QUALITY ACTION

CAMPAIGN BULLETIN

Electric Intake Valve Timing Control (eVTC) Module Dealer Inventory

Reference: PC624

Electric Intake Valve Timing Control Module Location

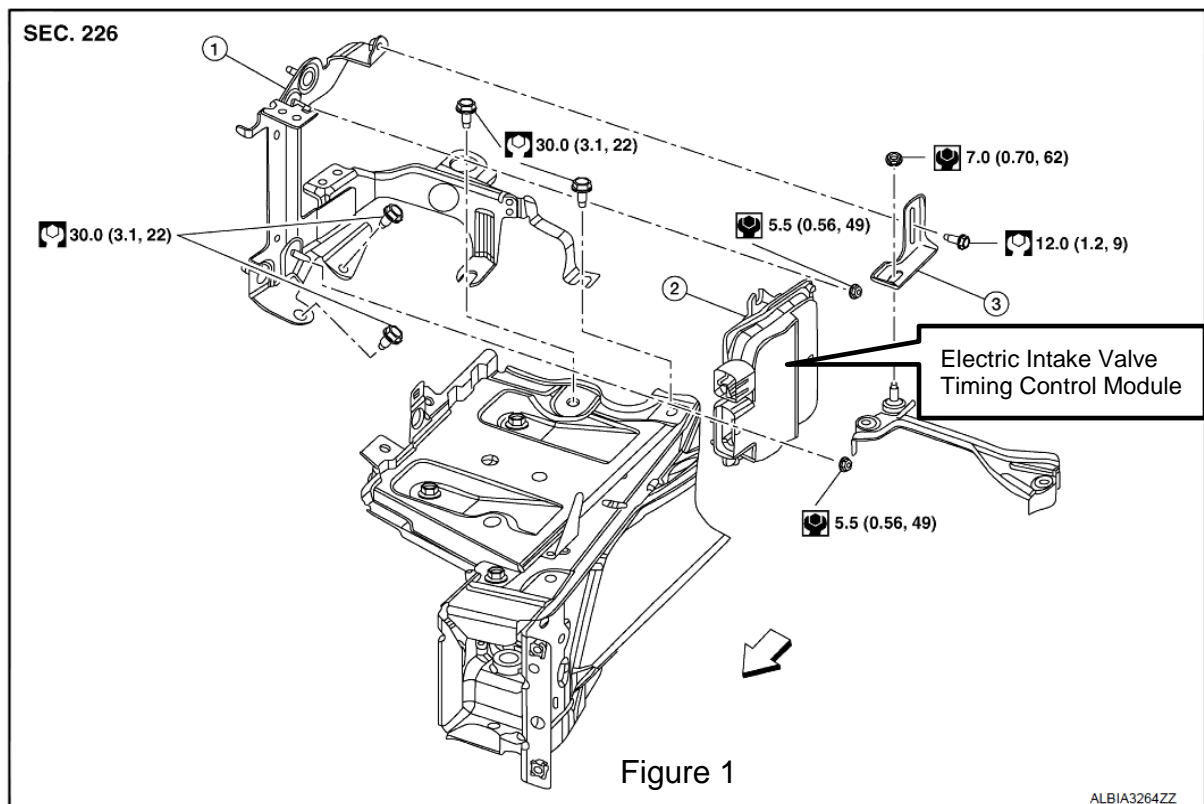
Replace the electric intake valve timing control module (see Figure 1).

CAUTION: Perform Electric IVT Control Actuator Position Learning after replacement of the module.

NOTE: If the Electric IVT Control Actuator Position Learning is not performed after replacement of the electric intake valve timing control module, the engine may not start.

Figure 2

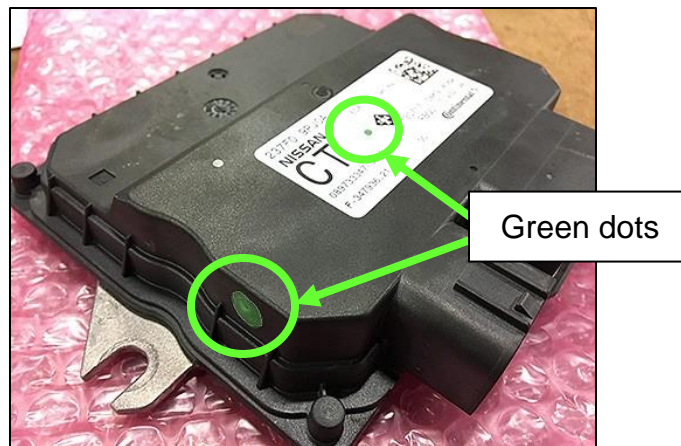
(1) The new part must either have the green dots as shown in Figure 2 **OR** the letters “AB” with an additional “QR” code on the label as shown in Figure 3 to indicate that it has the correct software version.
